RE: Variance Committee Review to allow for **Category F Driveway**

Project Name & Address: K-Park - 10400 Stribling Way

DRIVEWAY ENTRANCE MODIFICATION EXHIBIT

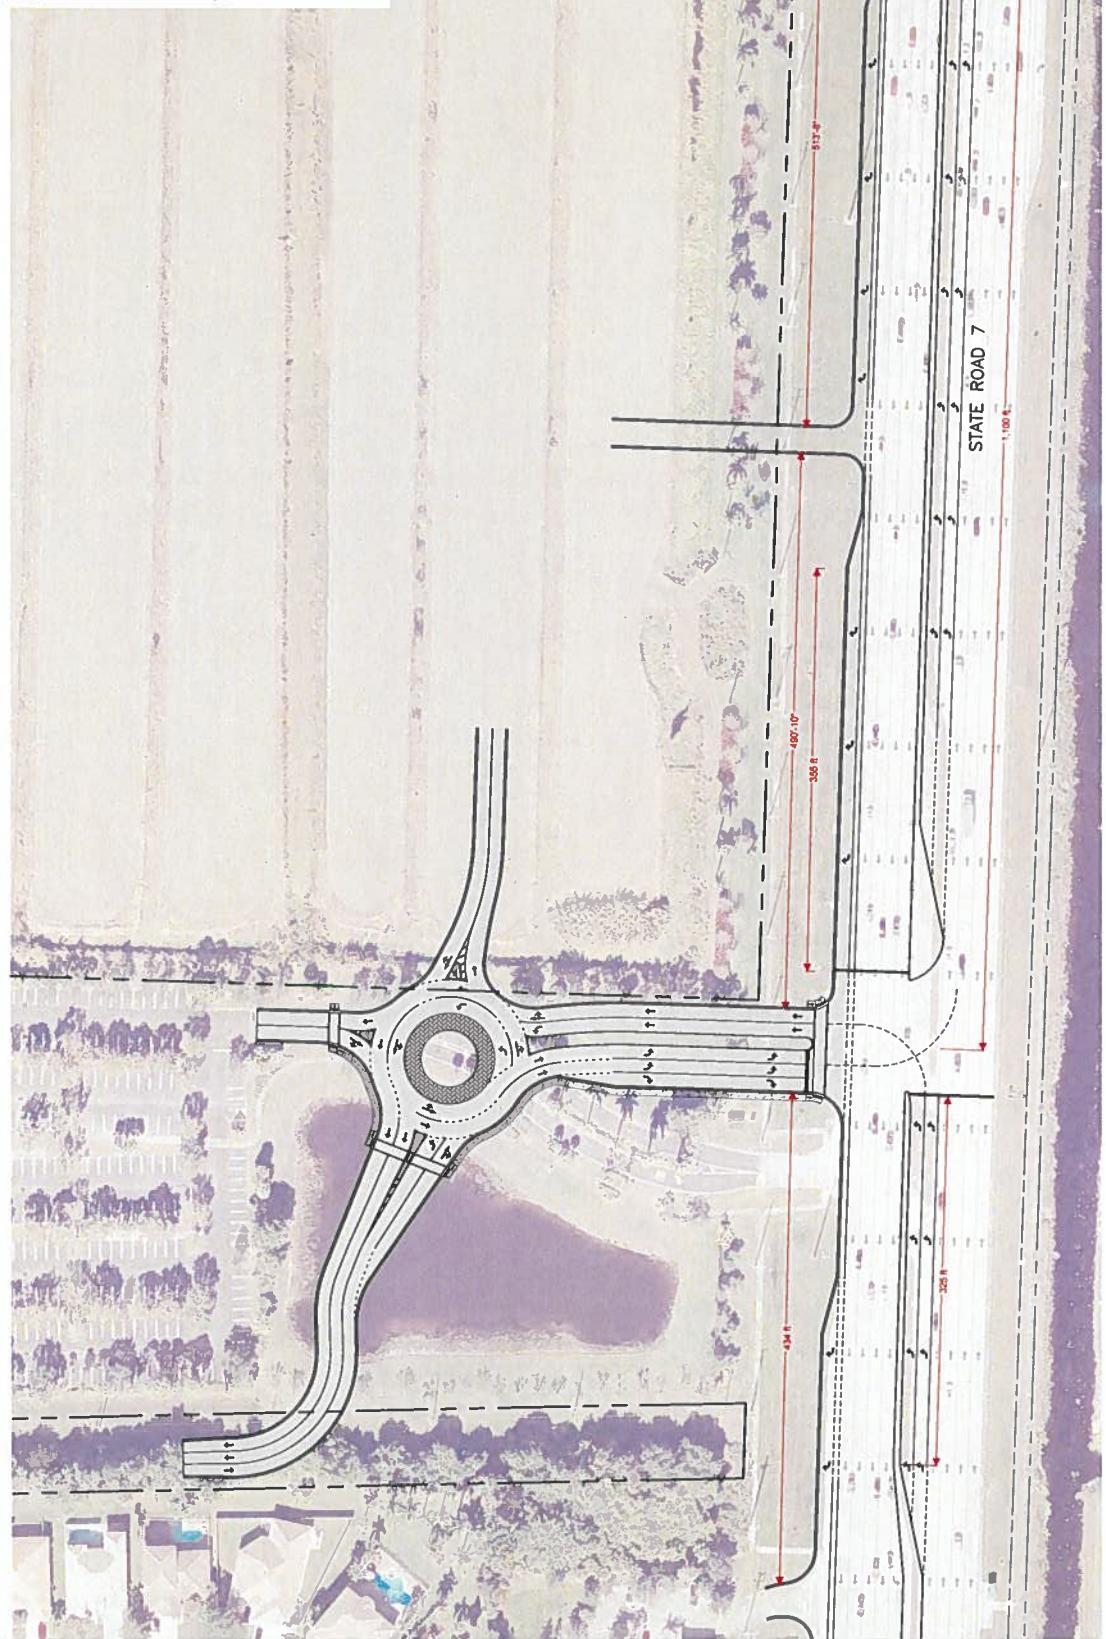
- **Driveway 1:** Proposed right-in/right-out driveway with right turn lane on the west side of SR 7, located approximately 514 feet south of Stribling Way.
- **Driveway 2:** Proposed signalized intersection on SR 7, located approximately 1,029 feet south of Stribling Way.
- Close the existing right-in/right-out/left-in driveway on the west side of SR 7, located approximately 1,153 feet south of Stribling Way.
- Remove the existing directional median opening on SR 7, located approximately 1,029 feet south of Stribling Way.

- Driveway 1** shall have a minimum driveway length of 100 feet, measured from the ultimate right-of-way line to the first conflict point in the driveway.
- The proposed signalized intersection (Driveway 2) shall have a minimum driveway length determined by a traffic study conducted by the applicant.
- The proposed multilane roundabout shall follow nationwide design guidelines (FDOT FDM Chapter 213). Queuing from the multilane roundabout's eastern approach must not encroach onto SR 7, as determined by a traffic study conducted by the applicant at permit.
- Right turn lanes are required for Driveways 1 & 2 and shall meet the minimum requirements in the Florida Design Manual (FDM) and shall provide space for a buffered bicycle lane.

- The queue length for the proposed northbound dual left turn lanes at Driveway 2 and the proposed dual northbound left turn lanes at the intersection of SR 7 and Stribling Way, must be determined by a traffic study conducted by the applicant at permit.**

- An Intersection Control Evaluation (ICE) Analysis conducted by the applicant at permit, is required for Driveway 2.**
- The proposed traffic signal support system shall have the structural capacity to implement a minimum of one signal head per lane with five section heads for all three approaches, as needed.**

- The following off-site improvements shall be implemented at the intersection of SR 7 & Stribling Way, by the applicant:**
 - An additional northbound left turn lane. The intersection shall be served by dual northbound lefts.**

- An additional eastbound right turn lane.**
 - An additional eastbound left turn lane.**
 - Extend the southbound right turn lane to meet minimum length as determined by a traffic study conducted by the applicant at permit.**

This request is: **Approved with Conditions**
